Access Compliance Report Public Rights-of-Way (Curb Ramps)

Intersection ID: 8226 Main Street: CATHERINE_SIMMONS_AV Cross Street: CUSTER_ST Location: SW

ADA ID: 1853A9BF3FF7 Ramp Type: PerpDiag Initial Pass/Fail: Fail Overall Compliance: No Severity Score: 33.75

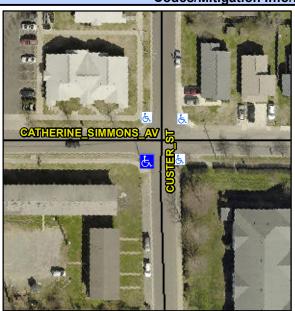
Not Found, R304.5.1, R304.2.2, R304.5.3

Compliance Description Data Compliance Description Data Compliance Description Data					
N/A	Ramp Length (in)	48.0	No	Ramp Slope (%)	9.3
No	Ramp Width (in)	45.5	No	Ramp XSlope (%)	6.8
N/A	Flare Type LT	N/A	N/A	Flare Type RT	N/A
N/A	Flare Slope LT (%)	N/A	N/A	Flare Slope RT (%)	N/A
N/A	Flare Traversable LT?	N/A	N/A	Flare Traversable RT?	N/A
N/A	Landing Length (in)	N/A	N/A	DWS Provided?	N/A
N/A	Landing Width (in)	N/A	N/A	DWS Contrast?	N/A
N/A	Landing Slope (%)	N/A	N/A	DWS Length (in)	N/A
N/A	Landing X Slope (%)	N/A	N/A	DWS Full Width?	N/A
N/A	Landing Curb? (Y/N)	N/A	N/A	DWS Offset (in)	N/A
N/A	Shared Landing?	N/A			
N/A	Gutter Ponding?	N/A	N/A	Gutter Slope (%)	N/A
N/A	Gutter Lip Ht (in)	N/A	N/A	Gutter X Slope (%)	N/A
N/A	Painted X Walk1?	No	N/A	Painted X Walk2?	No
	X Walk 1 Direction	То Е		X Walk 2 Direction	To N
N/A	X Walk 1 Width (in)	N/A	N/A	X Walk 2 Width (in)	N/A
	X Walk 1 Slope (%)	1.0		X Walk 2 Slope (%)	3.3

Remove & Replace Curb Ramp With Two New Directional Ramps or Equivalent.
